IDI Gazeley Brookfield Logistics Properties
Magna Park Extension: Hybrid Application
Supplementary Transport Assessment

Author/Amended by:	Authorised by	Date:	Version:
Jon Ashcroft Associate	Paget Fulcher Technical Director	1 February 2016	1

Appendix B – AECOM Technical Note 4

Project:	Highways England Spatial Planning Arrangement	Job No:	60343293
Subject:	A5 – Magna Park Extension	Date:	2nd November 2015
HA ref:	EM3 Leics-Lincs-Rut	Task:	L0003

Figure 1 – Location of M1 J20 and A4303 / A426

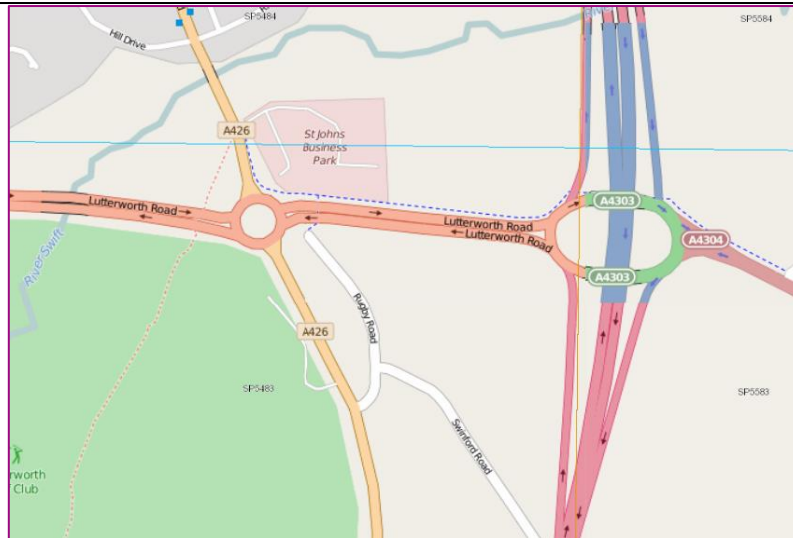
The roundabout is situated approximately 340m to the west of M1 junction 20 as shown in **Figure 1**, and appears to operate over capacity in the 2026 scenario. The approach from the west, critical to the operation of the SRN, operates at a maximum ratio of flow to capacity of 0.98, with queues of 23 PCUs – approximately 130m in length.

Appendix D – Distribution of Student Trips

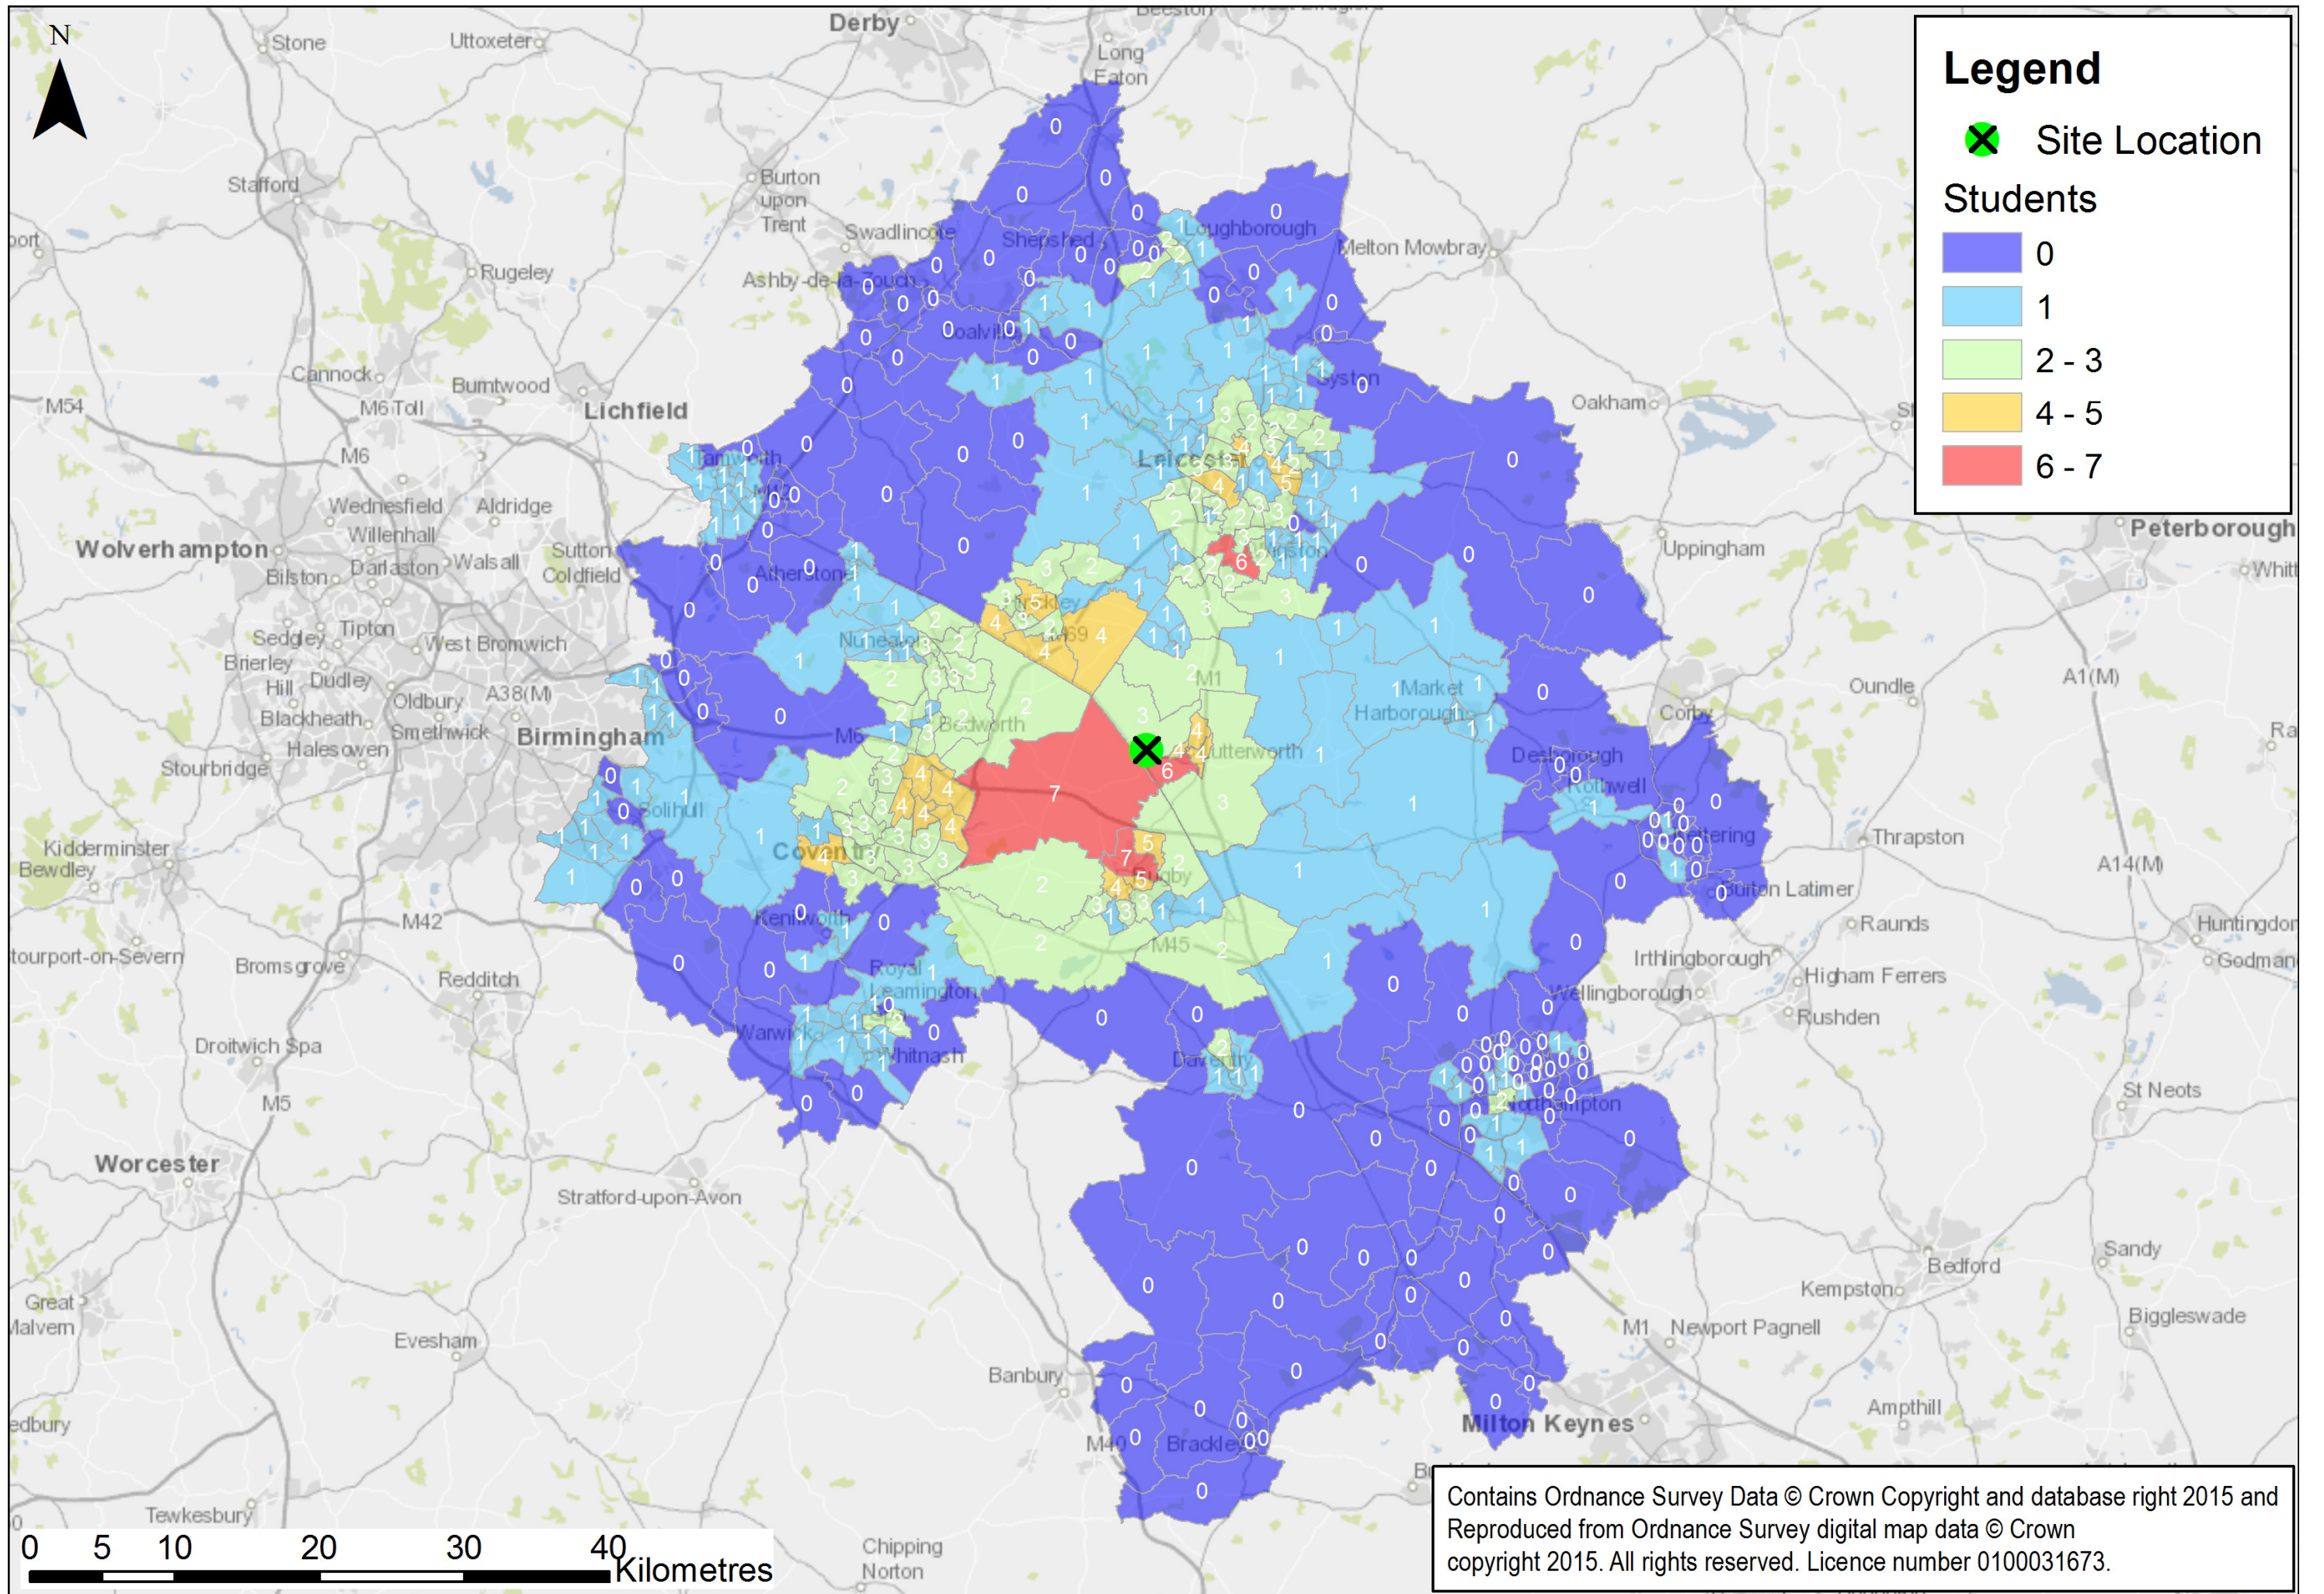
From review of the gravity model files provided in Appendix W, the number of likely students from the surrounding local authorities as shown in Table 6.12 appears to be reasonable. However, as the plan showing distribution of the student trips referenced in paragraph 6.52 has not been provided, the suitability of the proposed distributions of student trips on the road network as shown in Table 6.13 cannot be determined.

The plan showing distribution of the student trips referenced in paragraph 6.52 of the TA should be provided for review to allow its suitability to be determined.

- 2.8 A plan showing the distribution of student trips referenced in paragraph 6.52 of the original Transport Assessment is presented in **Appendix D**.

Drawing Title
**GIBBET HILL ROUNDABOUT
PROPOSED IMPROVEMENTS**

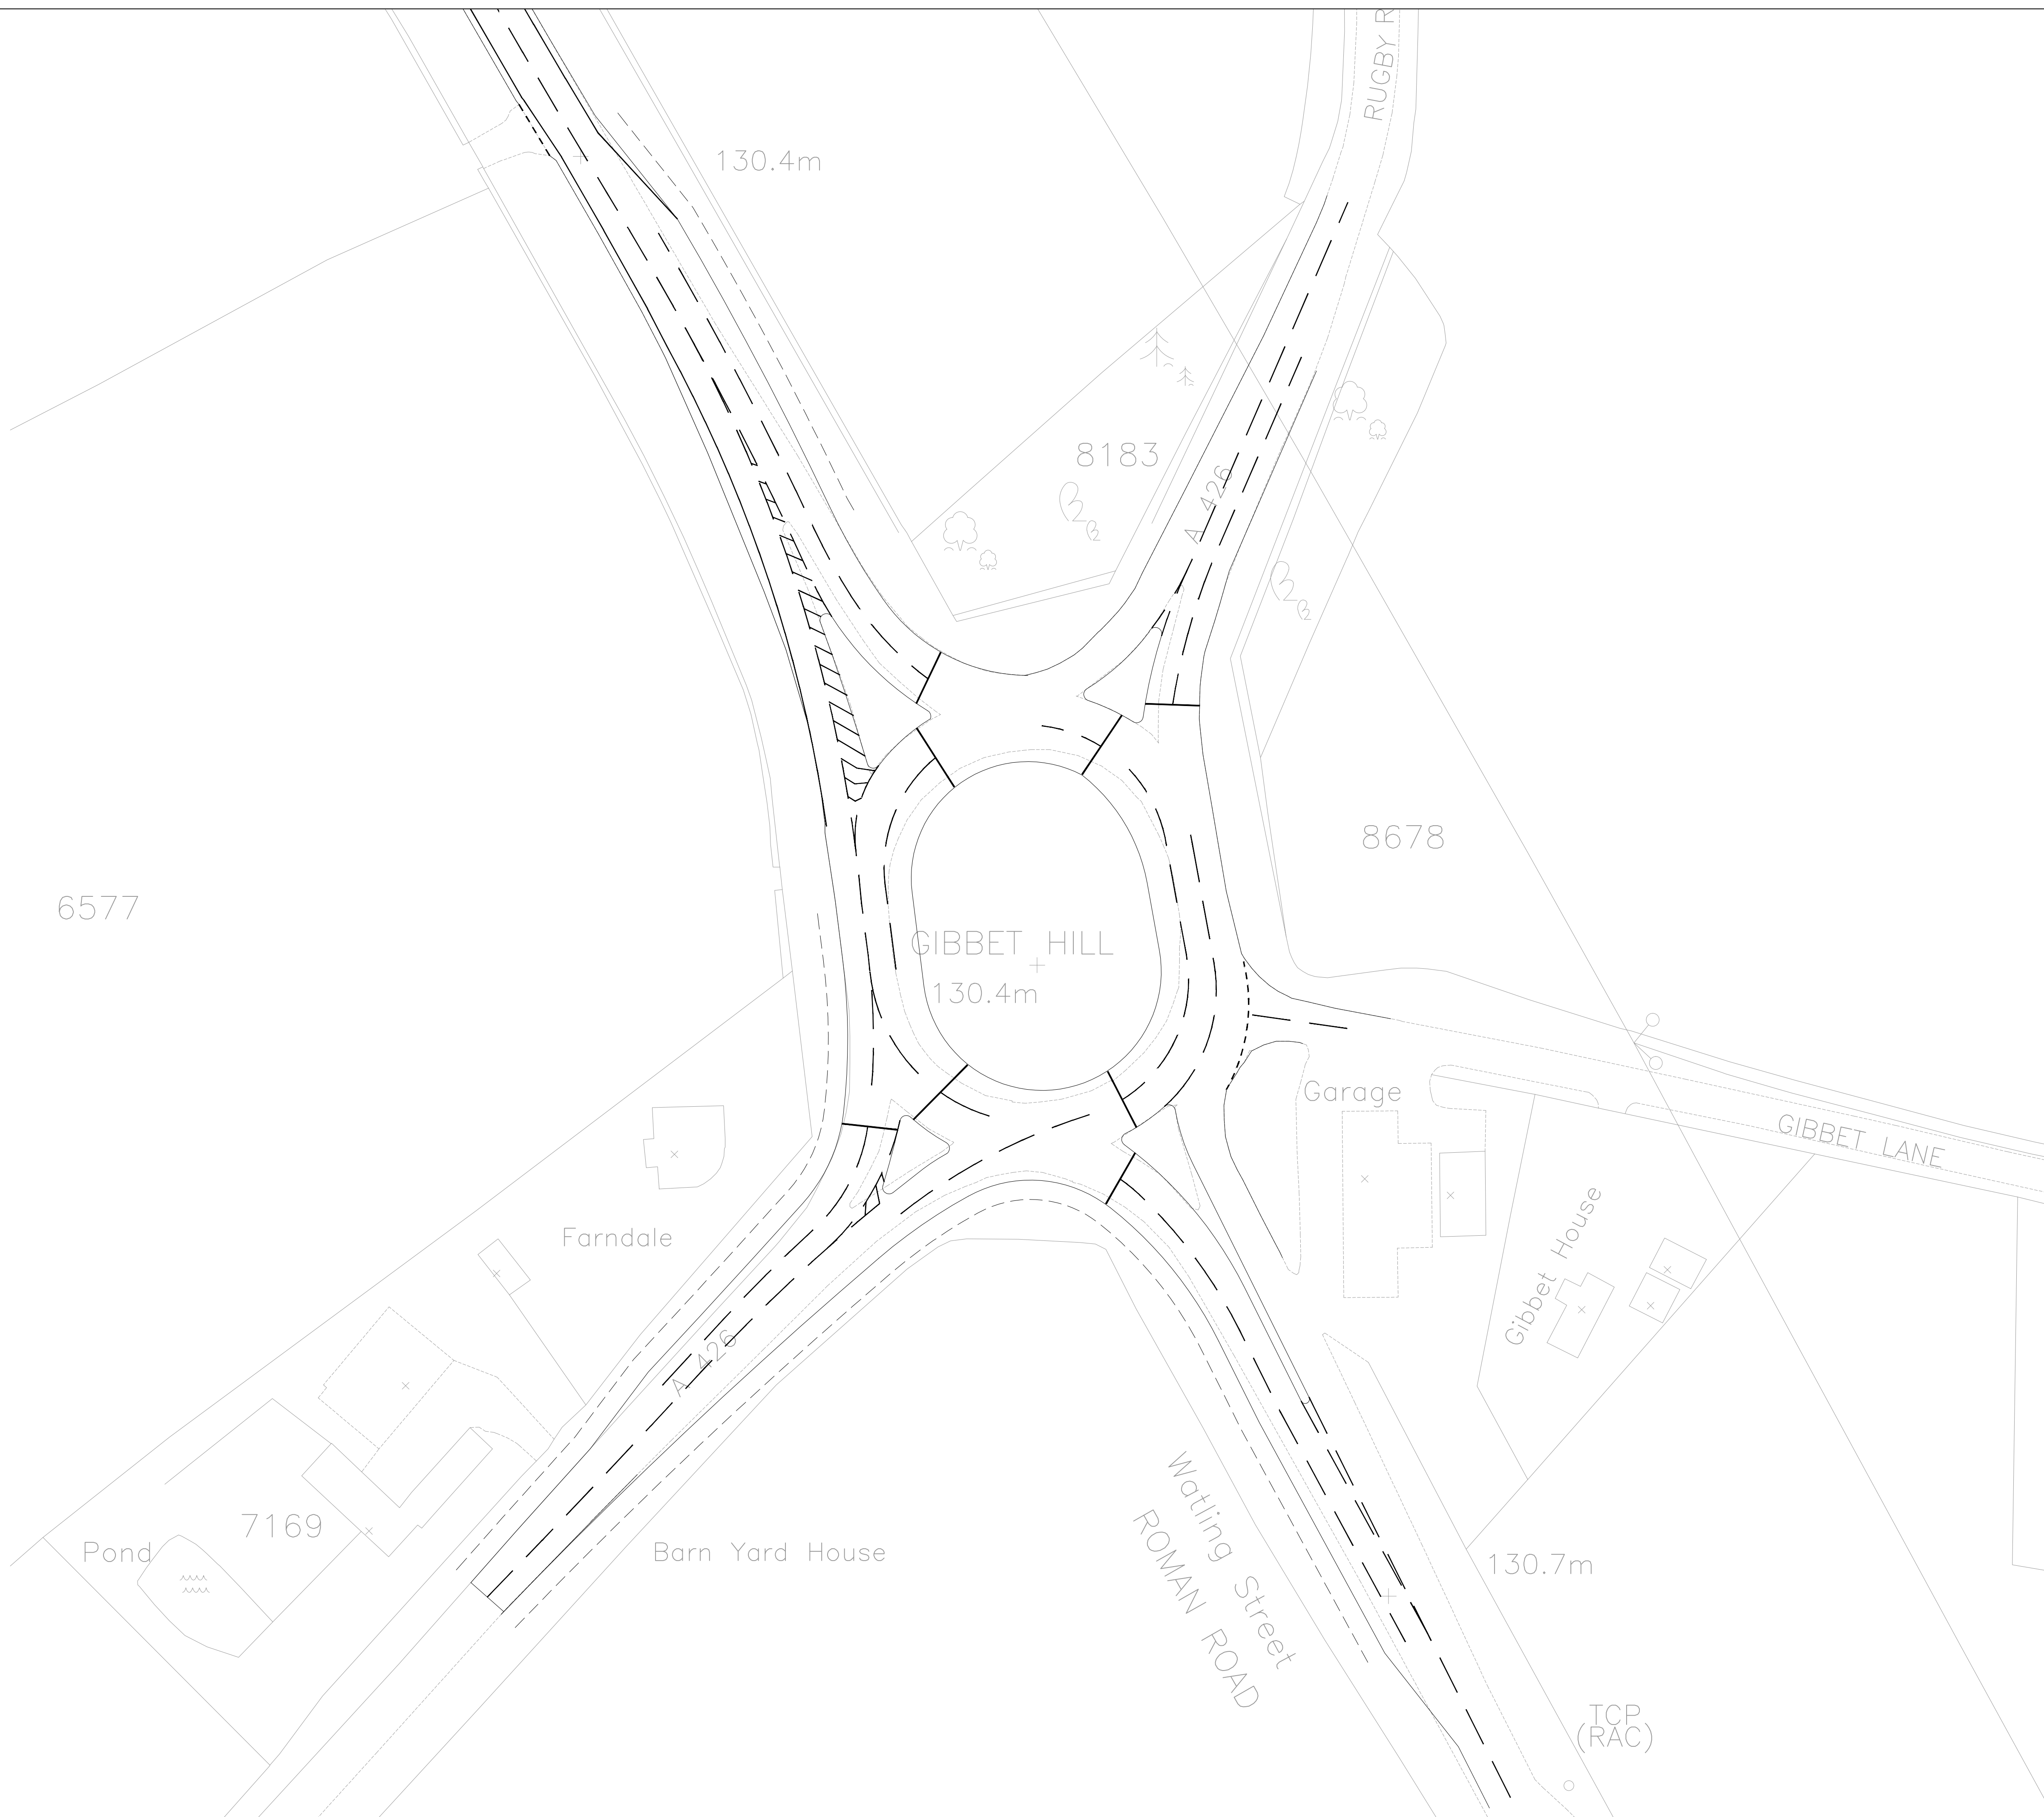
It is understood that DIRFT III is to provide mitigation at the Gibbet Hill roundabout, including widening and signalisation of the A5 approaches, and so this scheme has been included in the assessments carried out in this TA. There is a significant risk that should DIRFT III and its conditioned highway improvements not be delivered according to current plans, approval of this Magna Park application would be detrimental to the operation of this roundabout and the SRN. Based on this it will be necessary to apply a condition to the Magna Park application that no more than the 100,844m² of B8 previously reviewed in application 15/00919/FUL for the DHL development will be occupied until the Gibbet Hill roundabout improvement has been delivered.

There is a significant risk that should DIRFT III and its conditioned road improvements to the A5 Gibbet Hill roundabout not be delivered according to current plans, approval of this Magna Park application would be detrimental to the operation of this roundabout and the SRN. Based on this, a condition to the Magna Park application should be applied ensuring that no more than the 100,844m² of B8 previously reviewed in application 15/00919/FUL for the DHL development will be occupied until the improvement as conditioned to the DIRFT III development has been delivered.

- 3.1 In relation to Gibbet Hill roundabout IDI Gazeley does not wish to accept a condition that limits the amount of development that can be occupied at Magna Park prior to improvements being made to the junction. At the same time IDI Gazeley does not wish to rely on other developers to provide the necessary improvements at Gibbet Hill as this may delay the desired rate of occupation at Magna Park. IDI Gazeley is therefore proposing to partially signalise the Gibbet Hill roundabout to accommodate the proposed extension at Magna Park. A copy of the proposed layout is presented in **Appendix E**.

- 4.23 This assessment is based on junction improvements that are being proposed by IDI Gazeley in support of the Hybrid planning application at Magna Park. The scheme includes carriageway widening, improved carriageway markings and the signalisation of the approach and circulatory carriageways of the A426 north, A426 south, A5 north and A5 south. The improvements are shown on a drawing presented in **Appendix E** (Drawing No. 60470988/A001/SK32).
